RE: Revised Application Deficiency Report #4 - Certificate of Public Convenience and Necessity for the Riverside Transmission Reliability Project – Application No. A.15-04-013

DEFICIENCY REPORT #4 (REVISED) FOR THE RIVERSIDE TRANSMISSION RELIABILITY PROJECT APPLICATION (A. 15-04-013)

Table 1: SCE Riverside Transmission Reliability Project Application 15-04-013 Deficiency Report #4 (Revised 09/22/2016)

-  ROW
-  Tube Structure
-  Proposed Transmission Line
-  Indicative Access Road
-  GDAD Buffer Area
-  Cultural Survey Area

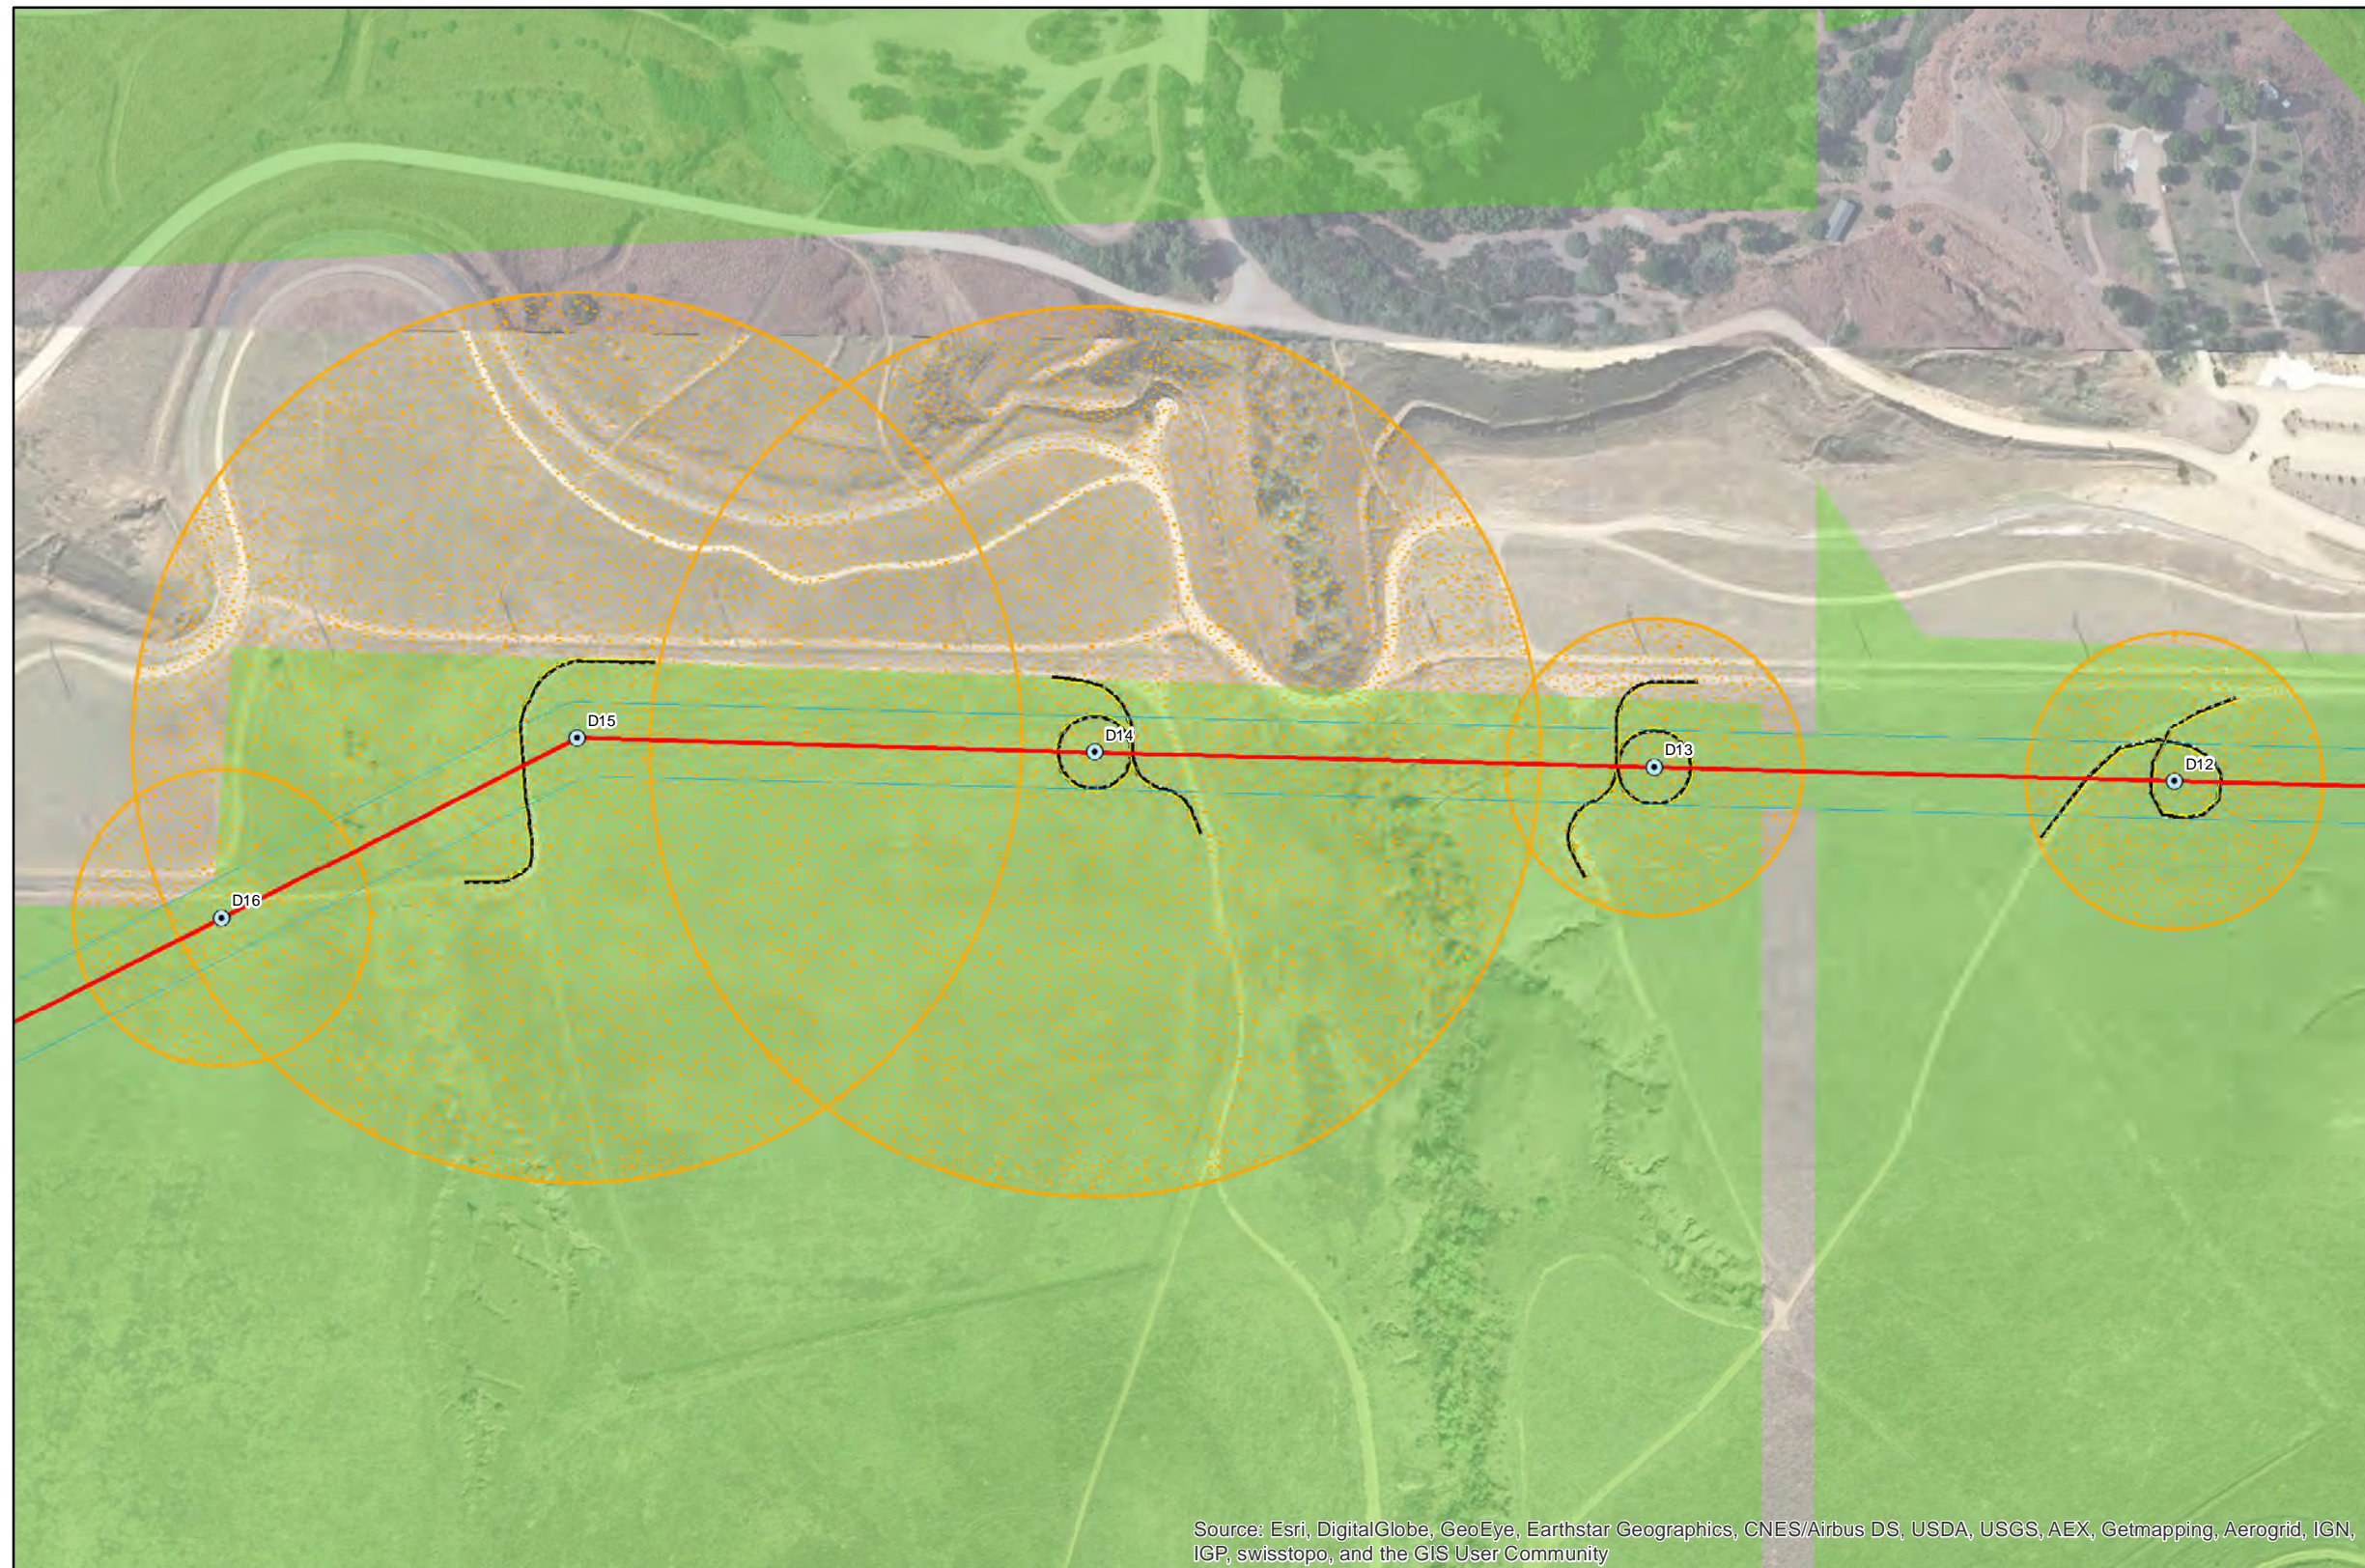
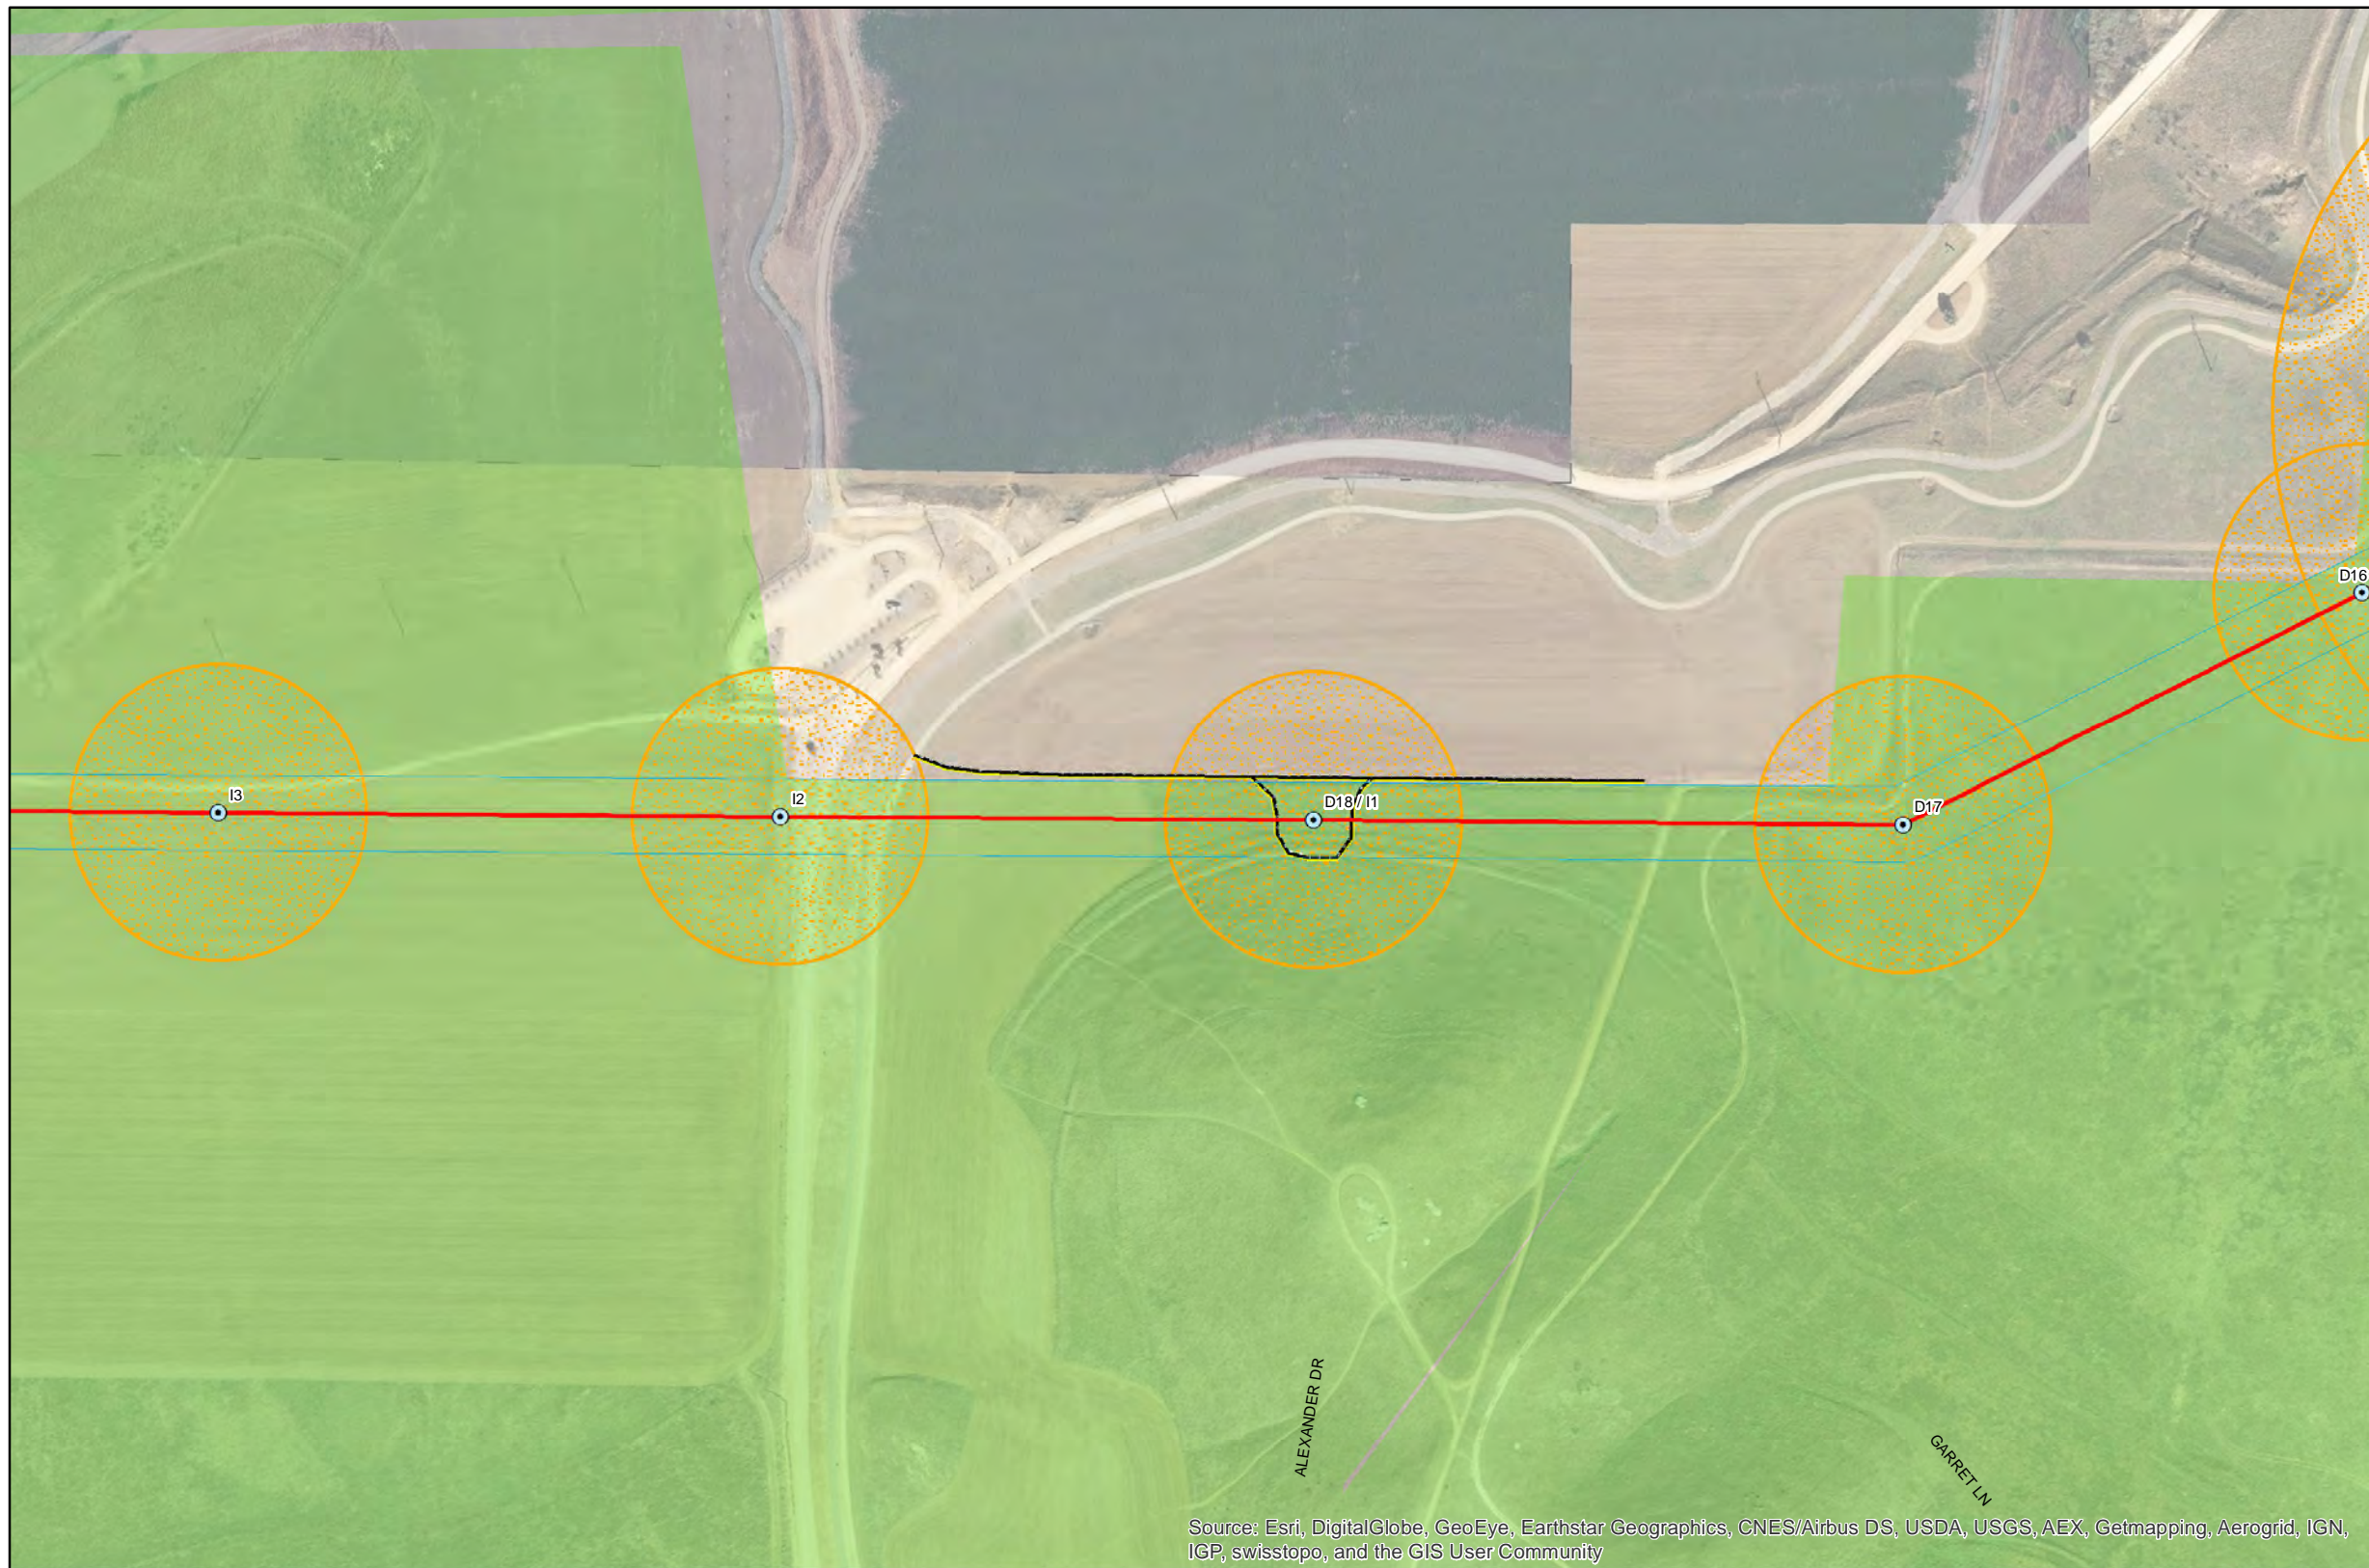
6	Yes	<p>Provide cultural resource survey reports and data for all unsurveyed portions of project disturbance areas as refined in response to Items 1 through 3</p>

Number	Information Requested Previously?	Deficiency
		<p>above (see also Attachment B) and the revised alignment northwest of the Santa Ana River.</p> <p>The cultural resource survey reports need to contain the results of a record search performed through the California Historical Resources Information System (CHRIS) – Eastern Information Center as well as the results of pedestrian surveys for all unsurveyed work areas along the overhead alignment including those areas shown on Attachment B, the agricultural area north of Limonite Avenue, and the underground alignment within the Goose Creek Golf Club. Please also provide the results of a cultural resources records search performed through the CHRIS for the proposed underground alignment within 68th Street and Pats Ranch Road. Provide all supporting details in the cultural resources survey report (i.e., site records and maps).</p>
7	Yes	<p>Clarify how SCE expects to obtain a permit for new poles located in the Hidden Valley Land and Water Conservation Fund (LWCF) area. How will NEPA be handled for new poles in this area? Where and how will SCE replace the impacted LWCF area?</p> <p>The Land Use section in the 2013 RTRP Final EIR lacks analysis of the land use impacts resulting from conversion of LWCF areas. Mitigation Measure REC-02 in the recreation section does not define where or how SCE would replace the LWCF area or obtain the necessary permits from the National Park Service. Further information is needed to verify the feasibility of the proposed “land conversion” for the proposed transmission line structures within the LWCF area.</p>
